### 6 NYCRR § 750-3.8(c)(2) Monitoring Requirements in HVHF SPDES Permits

## Appendix A

### TECHNICAL MEMORANDUM

Figure 1: FEMA Floodplain Map, Conklin, NY. Zone B is the area between the 100-year and 500-year flood lines.

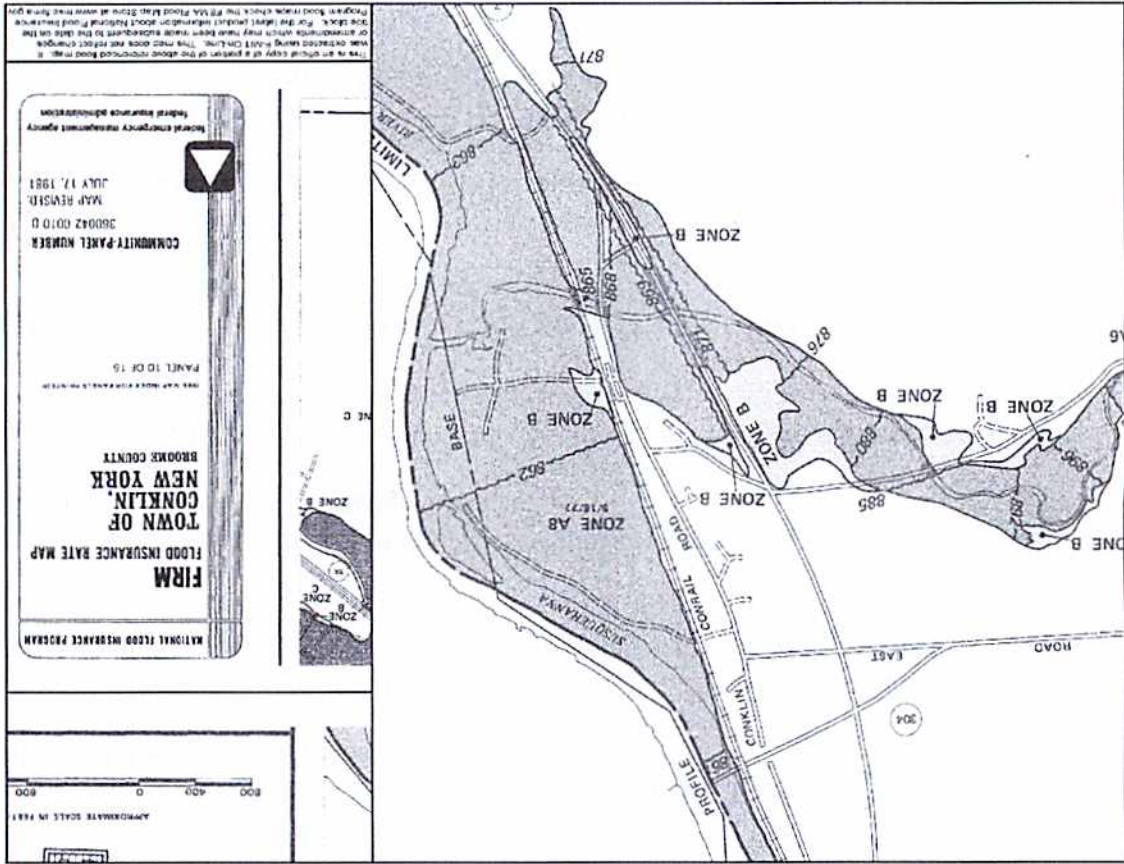
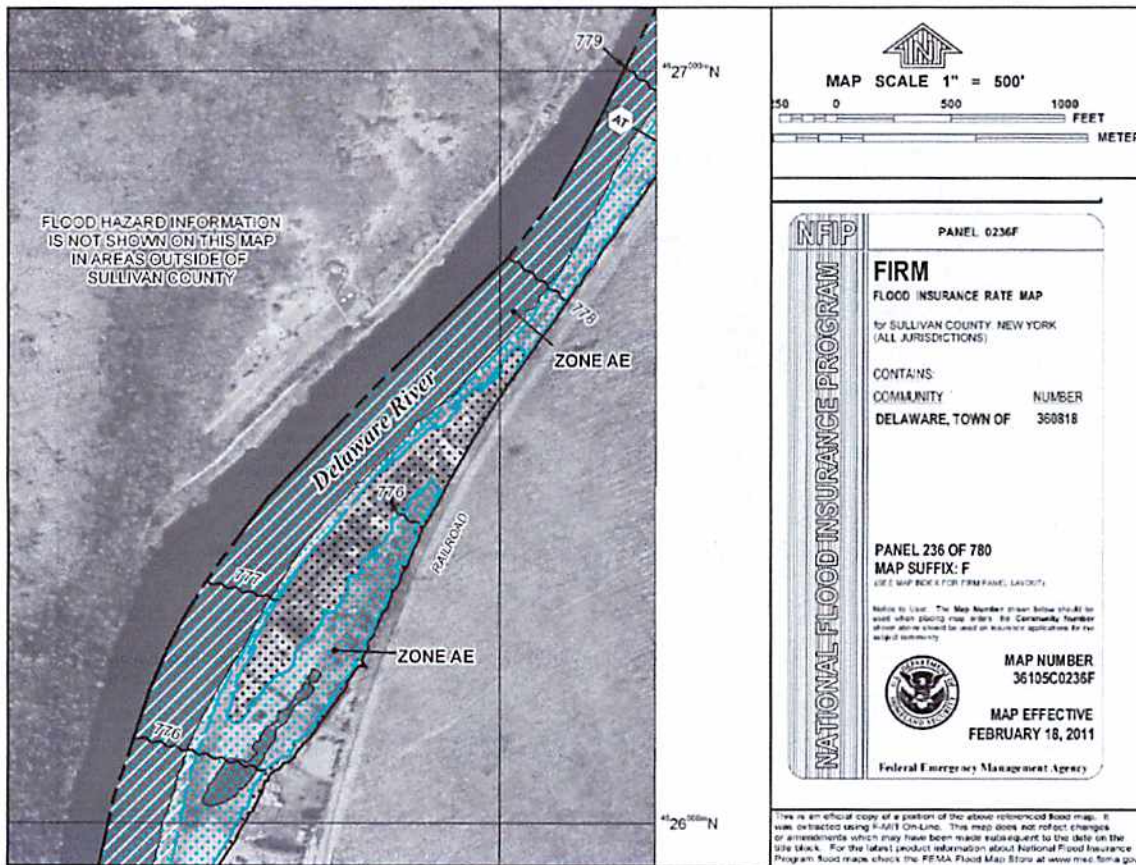
Actual floodplain maps show the difference between those completed 30 years or more ago and those more recently completed. Figures 1 through 3 are created from FEMA floodplain maps along the Susquehanna River in Broome County in 1981 and along the Delaware River and a tributary in 2011, respectively. More recent maps (Figures 2 and 3) show more detail. A

noticeable difference between the 100-year and 500-year floodplains is that the 500-year may just be a little wider than the 100-year but also that it fills in areas that may be above the water level in the 100-year flood. The restriction from developing gas wells within the 100-year floodplain would allow gas wells in the areas within the floodplain boundaries that are just higher than the water level. During the 500-year flood, most of the areas within the 100-year floodplain are filled in with water and the general boundary is spread horizontally a little further. The tributary in Figure 1 clearly meanders within the 500-year floodplain but some of the terraces on the meander bends are actually above the 100-year but within the 500-year floodplain. In Pennsylvania, operators have even developed Marcellus Shale gas wells within the existing 100-year floodplains (Figure 4). There is clearly a need to restrict development near the streams.
